Wisconsin Department of Transportation

Proposal #08: 1100-46-70, WISC 2021476
IH 41 Airport Freeway
60th Street Bridge
IH 041
Milwaukee County

This is Addendum No. 01, which provides for the following:

ADDENDUM NO. 01

**Addendum No. 01
ID 1100-46-70
Added Sheet 236A
August 31, 2021**

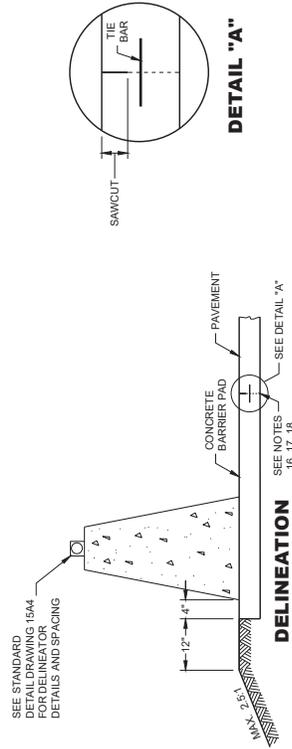
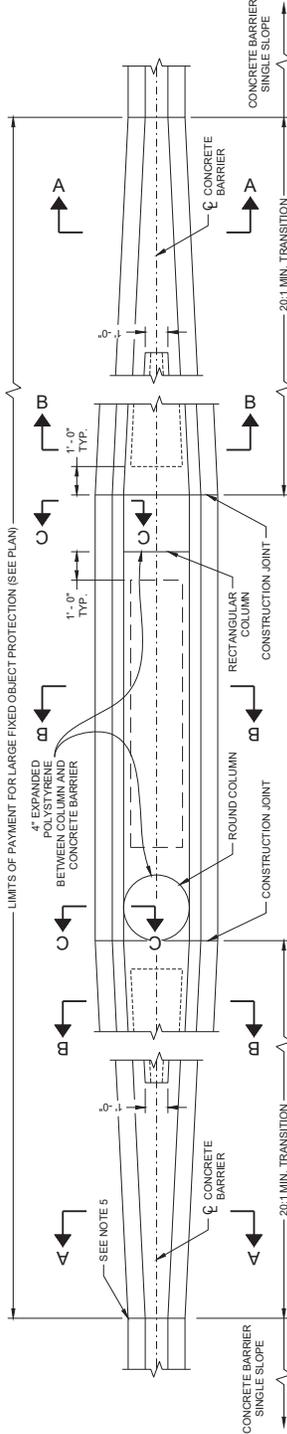
ADDENDUM to this SDD 8/14/2021: DELETE GENERAL NOTES 13 AND 14
